From: [Drouin, Mary](#)
To: [ANDERSON, Victoria](#)
Cc: [Purnell, Blake](#); [Weerakkody, Sunil](#)
Subject: nrc review of 17-07 11-8-18.docx
Date: Friday, November 09, 2018 1:49:48 PM
Attachments: [nrc review of 17-07 11-8-18.docx](#)

Attached is NEI 17-07 with NRC draft review comments in preparation for upcoming public meeting on Nov 14, next Wednesday. We will be putting this into ADAMS, may not make it until Tuesday.

PERFORMANCE OF PRA PEER REVIEWS USING THE ASME/ANS PRA STANDARD

Figure 1-1: Peer Review Process

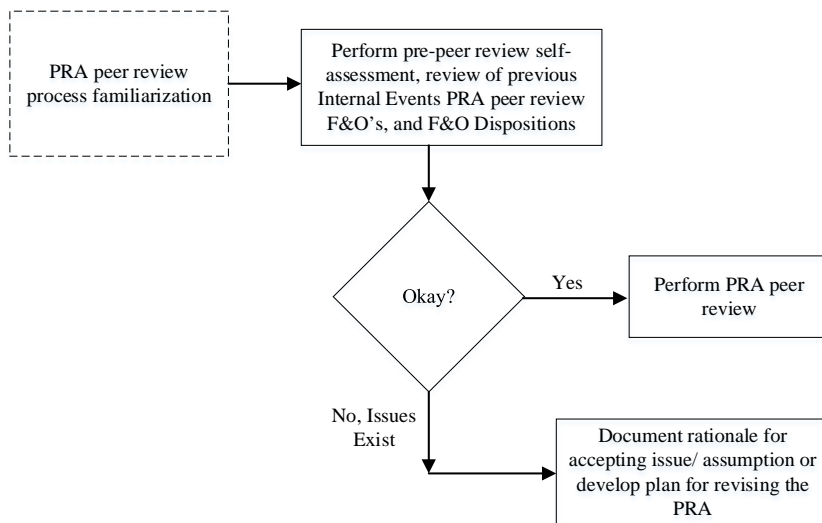
Commented [NRC28]: When issues exist, who is performing the documentation or developing the plan?

Figure 1-2: FPRA Peer Review Process Flow Chart

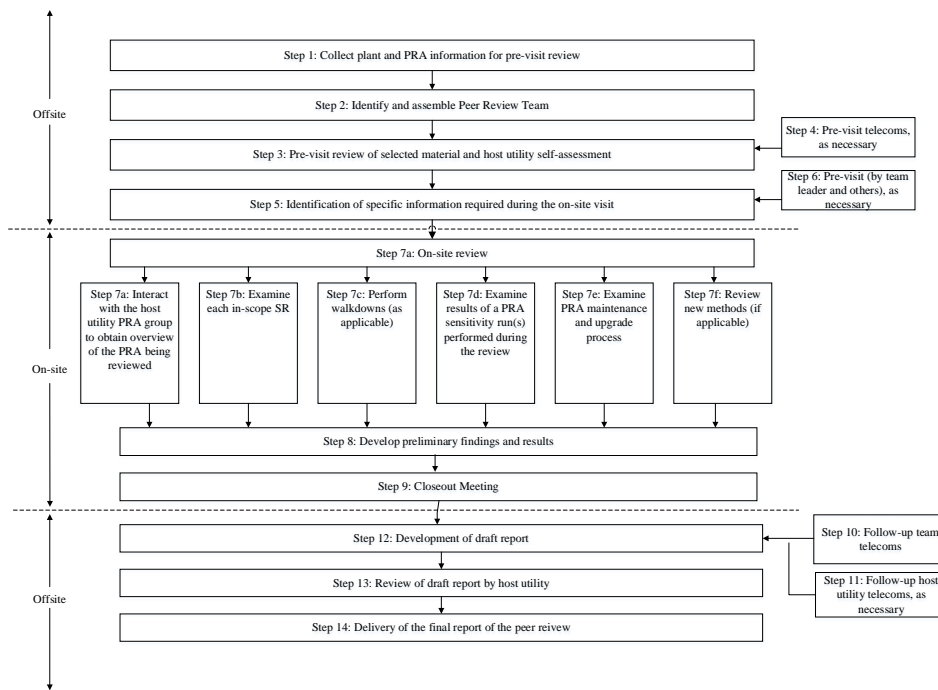
Commented [NRC29]: Title is too similar to Section 5.1
